Technical Information

TECHNICS CD

MAY 1987

MODELS: SL-P520, SL-P720

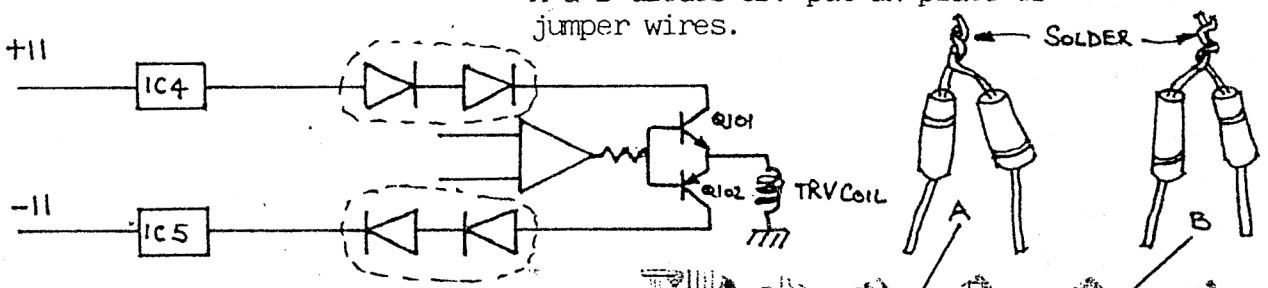
METHOD: (1) Replace Q11 and Q101 by 2SC1846
Q12 and Q102 by 2SA885
New transistors are larger and have to be fitted as shown.

(2) Add 4 diodes in series with connectors of transistors to reduce the voltage as shown.

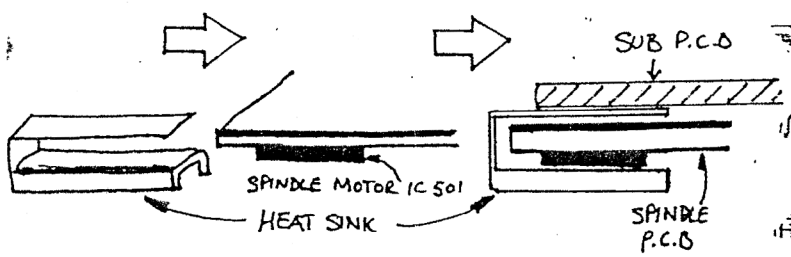
A & B diodes are put in place of jumper wires.

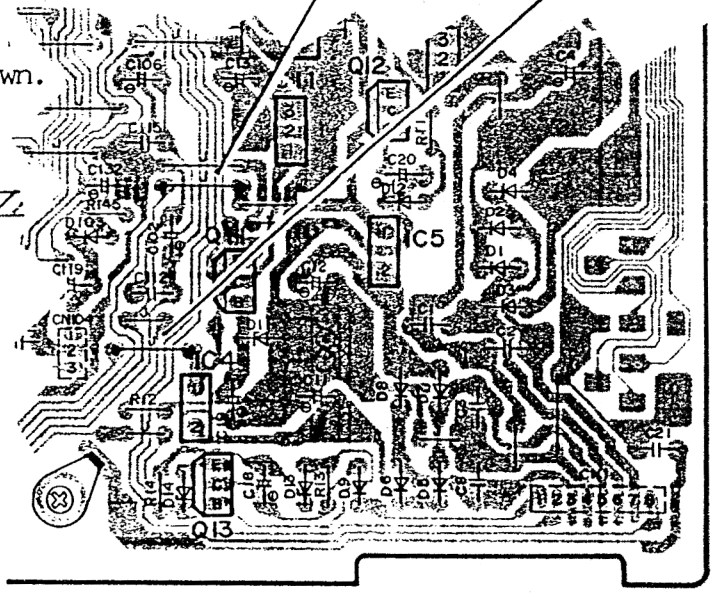
(3) Add heat sink to spindle IC501 as shown.
